***Southwest Coastal Design Review / Citizen Advisory Committee  
Regular Meeting***

4. ACTION ITEM (6:10 – 7:00 p.m.):  
Major Design Review and Expansion of a Non-Conforming Structure: In the matter of two applications submitted by Debra Birkby for the Expansion of a Non-Conforming Structure and Major Design Review for a residential addition (dining room). The subject property is identified as T4N, R10W, Sec. 30CB TL 00700 and commonly known as 79829 Gelinsky Road, Arch Cape, OR.

## **STAFF REPORT**

**REQUEST:** The applicant is requesting: 1) Expansion of Non-Conforming Structure and 2) Major Design Review for a residential addition (dining room).

# PLOT PLAN

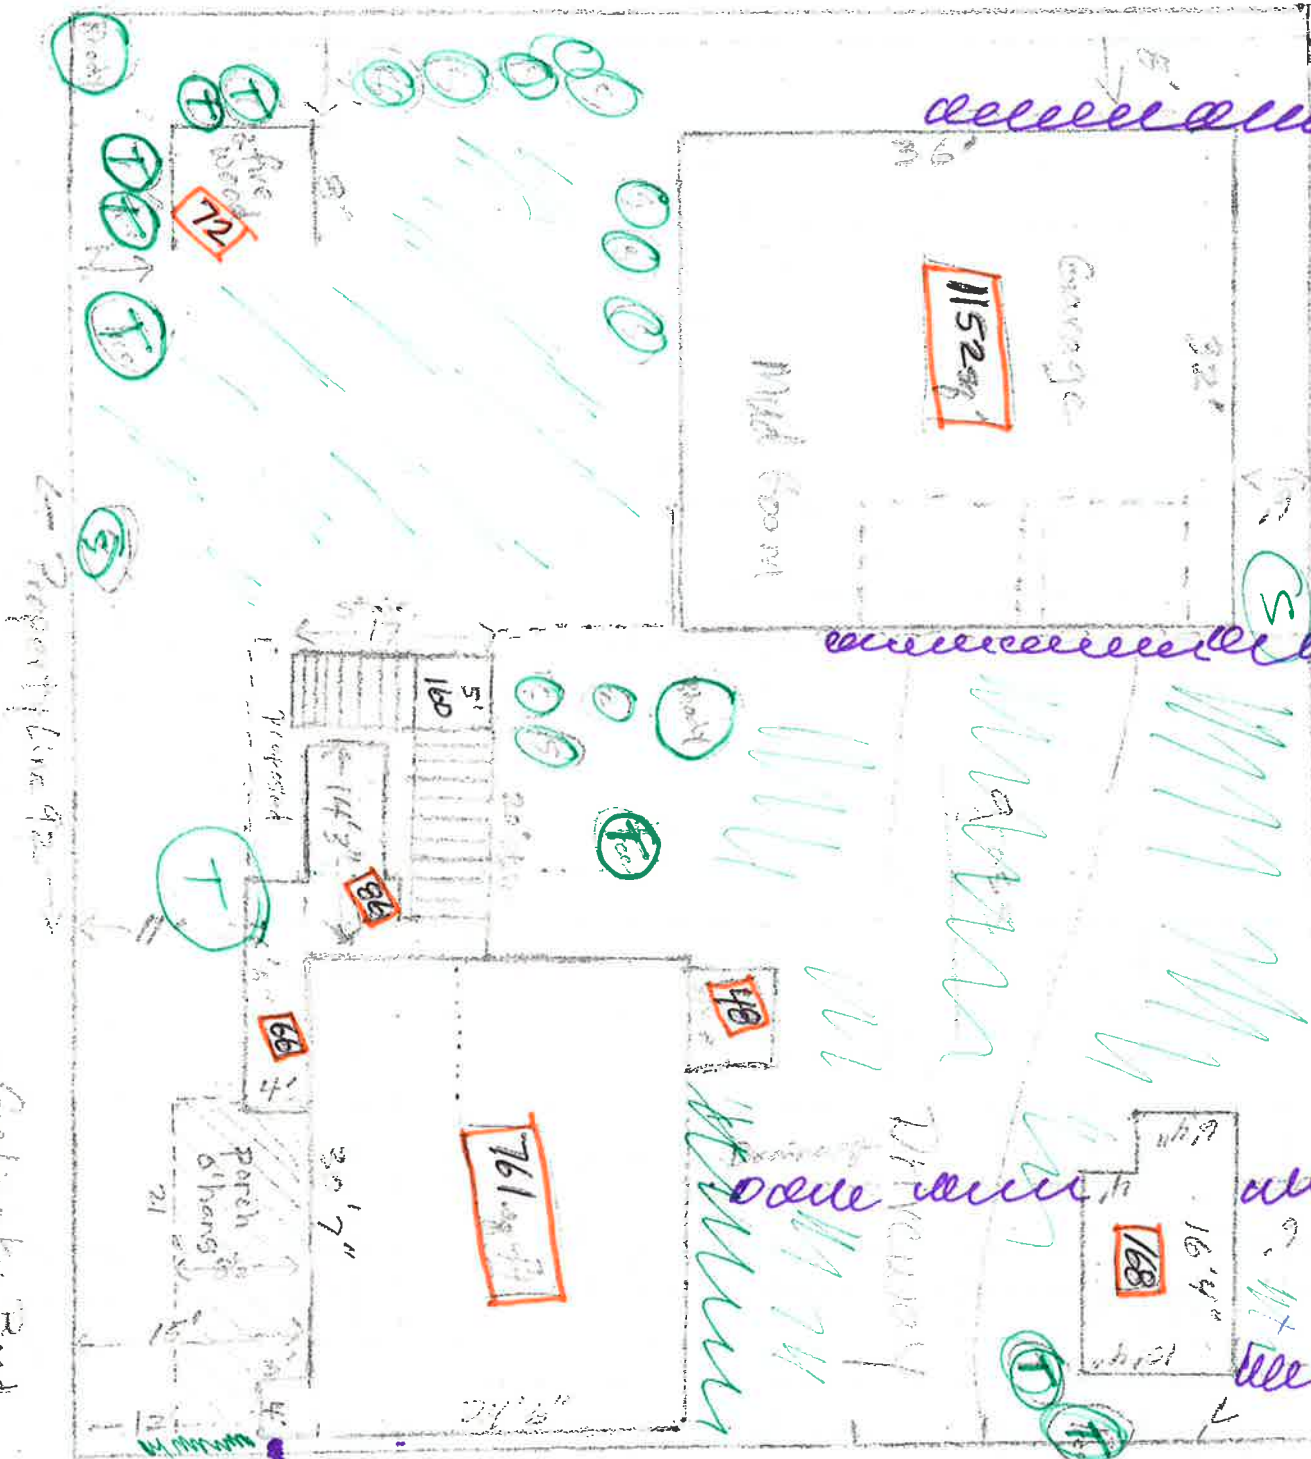
The site plan provided by the applicant shows the dwelling set back 11-feet from the western property line (right-of-way) along Gelinsky Road. This does not meet the 20-foot front yard setback identified in L3.068(2) is not met. However, section S4.504(3) *Protection of Riparian Vegetation* allows the reduction of a setback, without a variance, to a width of no less than 10-feet opposite a riparian area. This results in a conforming front yard setback for the subject property.
